BAW-10174A

Mark-BW Reload LOCA Analysis  
for the  
Catawba and McGuire Units

SUBJECT: SAFETY EVALUATION OF "MARK-BW RELOAD LOCA ANALYSIS FOR THE  
CATAWBA AND MCGUIRE UNITS" BAW-10174

SAFETY EVALUATION BY THE OFFICE OF NUCLEAR REACTOR REGULATION  
RELATING TO TOPICAL REPORT BAW-10174, REVISION 1  
MARK-BW RELOAD LOCA ANALYSIS FOR CATAWBA AND MCGUIRE UNITS  
DUKE POWER COMPANY  
CATAWBA NUCLEAR STATION AND MCGUIRE NUCLEAR STATION  
DOCKET NOS. 50-413, 50-414, 50-369, 50-370

FIGURE 4-2b RELAP5/MOD2-B&W I.BLOCA NODING DIAGRAM

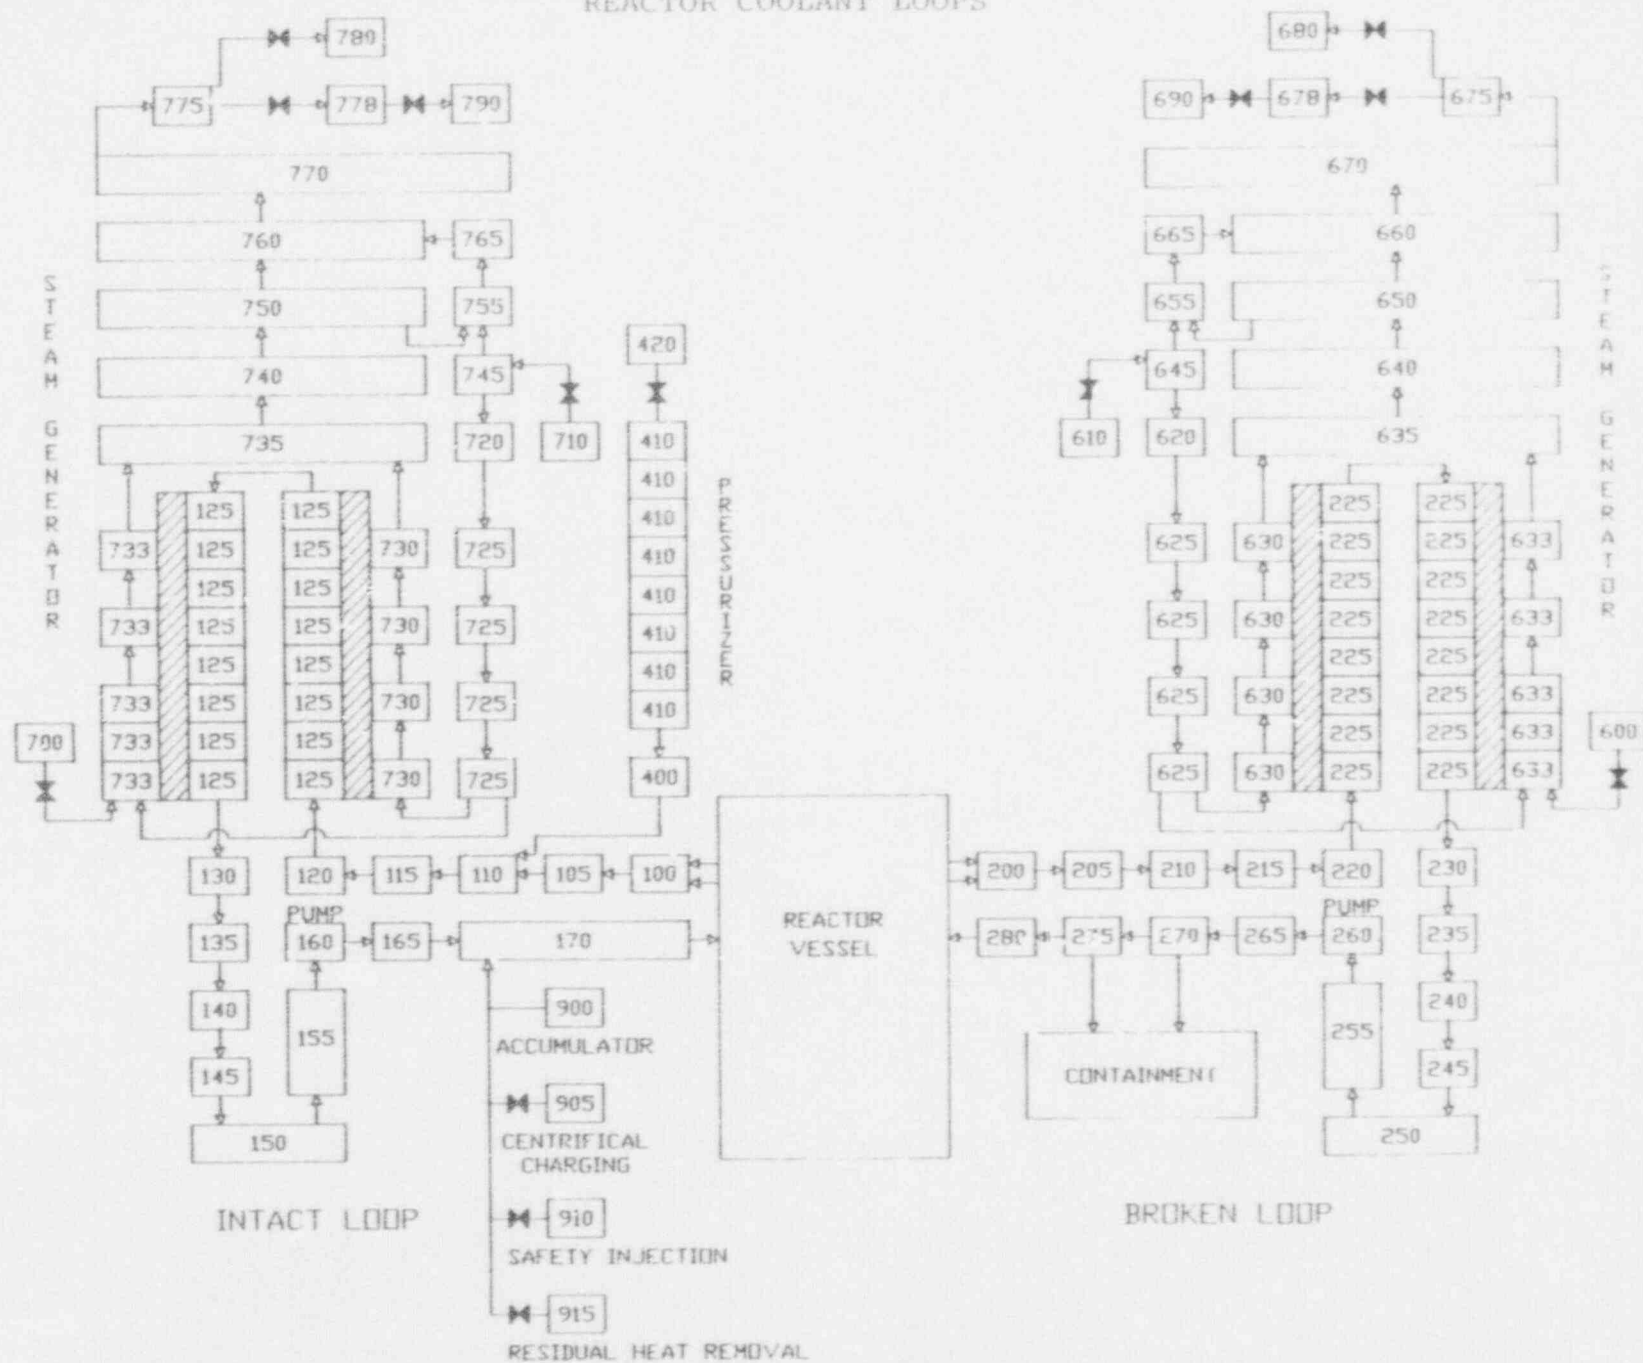
5. On page 4.4, the statement was made that the upper head model in Figure 4-2b was different from the model in EAW-10168, Figure 4-3. However, the two figures referenced are the same. Clarify the meaning of the statement.

Response: Figures 4-2 and 4-3 of the RSG LOCA evaluation model topical report, BAW-10168, Revision 0, were inadvertently changed to McGuire/Catawba figures in Revision 1 of the report. These figures should have remained characteristic of a non-UHI plant because the model, used to perform the evaluations and sensitivity studies reported in BAW-10168, was for a standard 4-loop 3411 Mwt plant. Figures A-1 and A-2 of Appendix A of the evaluation model report are appropriate and correct for the report. Figure 4-2b of the McGuire/Catawba report shows an additional node in the upper plenum over Figure A-2 of the EM report. Although the UHI system has been removed from service (valved out), the upper plenum internals for McGuire/Catawba remain slightly altered from the conventional 3411 Mwt non-UHI design. The additional node allows the representation of these UHI internals structures.

Although the RELAP5/MOD2-B&W nodding diagrams in chapter 4 do not specifically apply for the report, they are not considered inappropriate as they represent a legitimate application of the evaluation model. The correct nodding is given in Figures A-1 and A-2 of Appendix A which documents most of the studies used by the report. Therefore, the figures of Chapter 4 are not substantially misleading and need not be revised immediately. They will be replaced with the original Revision 0 figures when the report is next revised.

FIGURE 6-2 TACO3 FUEL TEMPERATURE AS A FUNCTION OF BURNUP

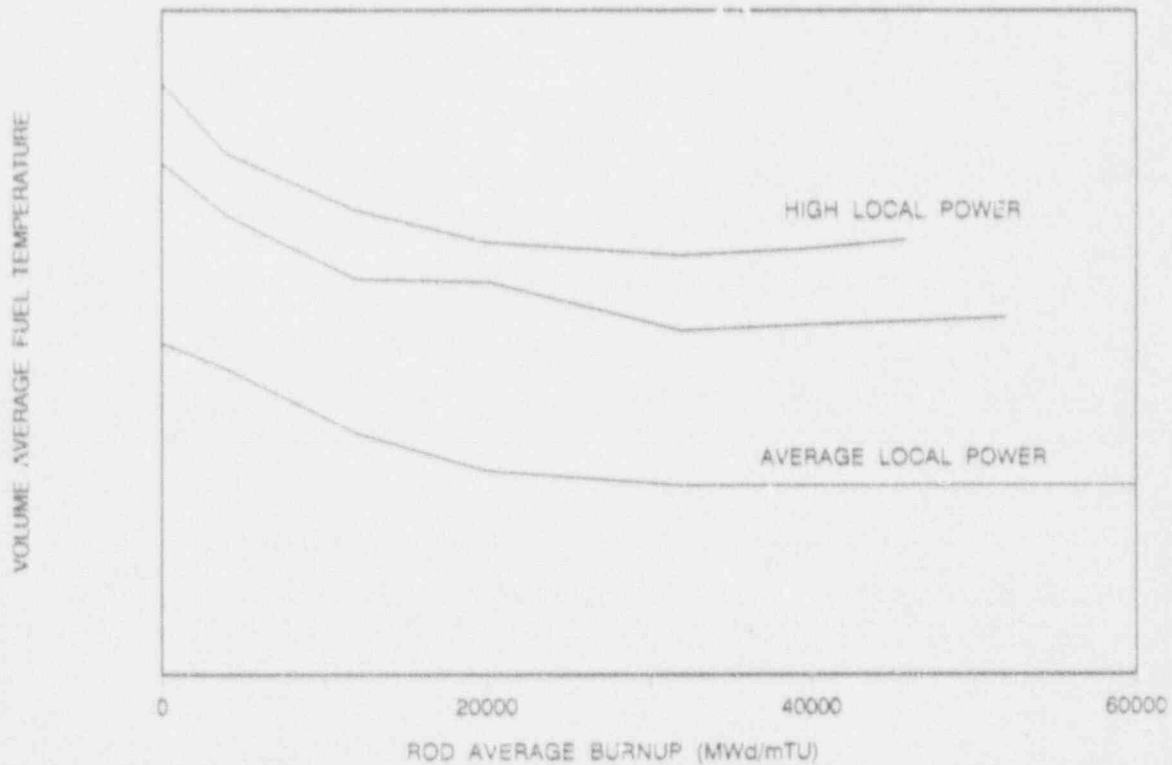
10. Section 6.2 contained information on the time-in-life study. Provide Figure 6-2 with a log scale on the x-axis to verify the fuel stored energy is the greatest at a burn-up of 1 MWD/Mtu. Also, clarify why the time of maximum stored energy for the Catawba/McGuire submittal differs from the LOCA EM study. If the difference is due to using a different steady state fuel code (i.e., TACO2 versus TACO3), clarify the code differences that result in the different times of maximum stored energy.

An expansion of Figure 6-2 will show the trend--fuel stored energy, starting at BOL, decreasing with increasing burnup--as described in Section 6.2 of BAW-10174. TACO3 will predict BOL as the time in life having the maximum fuel stored energy, since BOL is the time of maximum fuel/clad gap. Note that the fuel/clad gap decreases with increasing burnup thereby tending to lower fuel temperatures with increasing burnup. Of importance is the reason why TACO exhibits such a trend, and TACO2 does not. TACO2 stored energy predictions achieve a level of conservatism through a combination of conservative code and input modeling. Primary among these is the treatment of fuel densification. This issue has been addressed in the response to question 3 on BAW-10141 (TACO2 Fuel Pin Performance Analysis), which states in part:

FIGURE 7-44 MAXIMUM ECCS STUDY - DECLB,  $C_d = 1.0$   
MINIMUM ECC PUMPED INJECTION CONTAINMENT PRESSURE

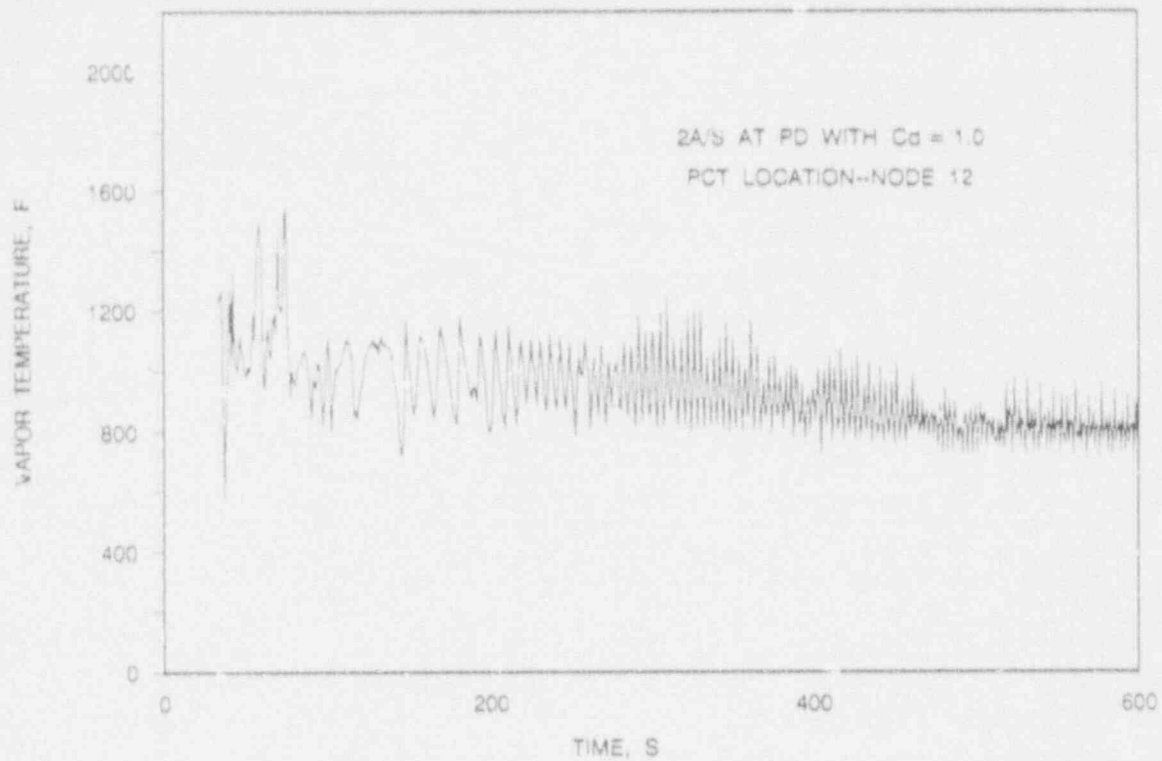
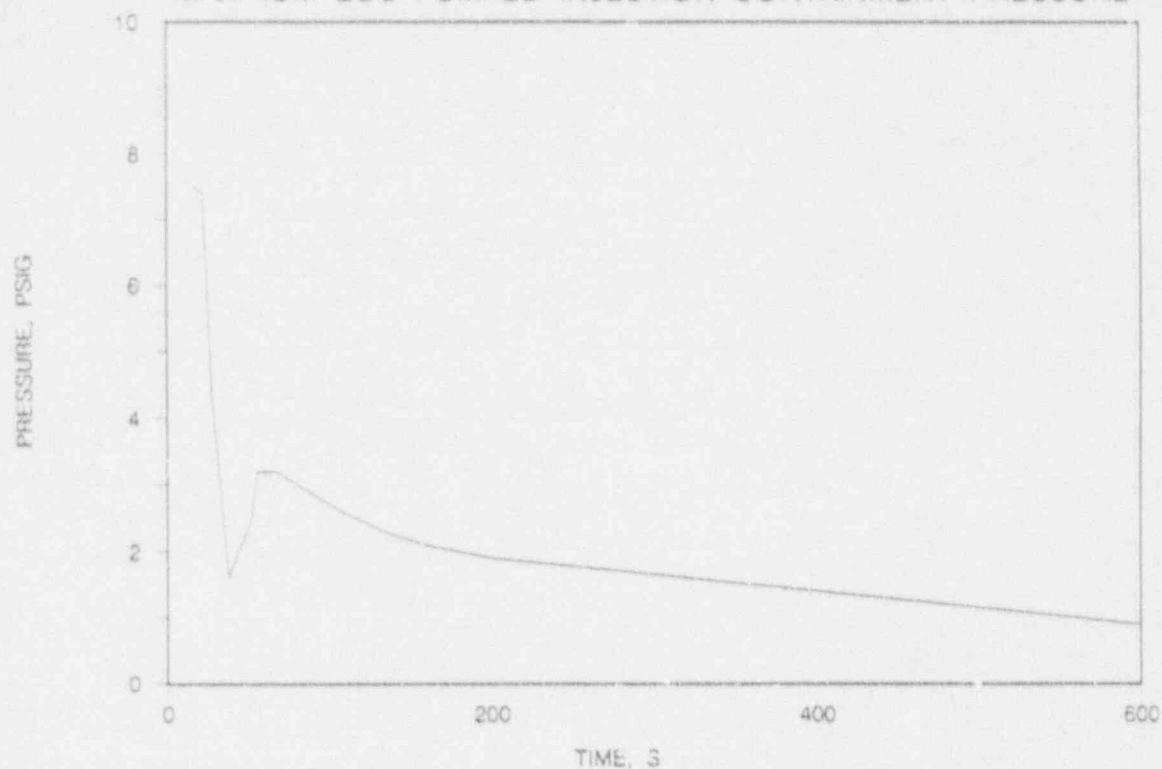
- d. Clarify if the containment pressures in Figures 7-44 and 7-47 were taken from the Catawba FSAR as discussed on Page 4-9. If not, discuss how the pressures were calculated.

Response: Figures 7-44 and 7-47 are from the minimum containment pressure curves of the Catawba FSAR. Comparison to the Duke applications report plots to Figures 15.6.5-41 and 15.6.5-42 of the Catawba FSAR (included as an attachment to the response to question 8.c.) substantiates this. The FSAR information was linearly extrapolated from the endpoint at approximately 234 seconds out to 600 seconds to provide needed boundary condition data for the reflood analysis in this period.
